# UNITED STATES PATENT AND TRADEMARK OFFICE

## Office Action Summary

10/806,653

## **DETAILED ACTION**

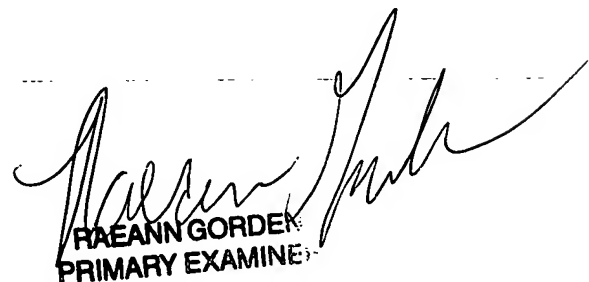
Claims 1-7 are rejected under 35 U.S.C. 102(e) as being anticipated by Winskowicz (6,358,160). Winskowicz discloses a golf ball that changes performance characteristics once immersed in water for several days (col. 2). Winskowicz further discloses that it is well known that golf ball recovered after being exposed to water have

a change in carry and coefficient of restitution (hardness) (col. 1). The golf balls are tested using golf clubs. See figure 1, where the golf ball is immersed into the water.
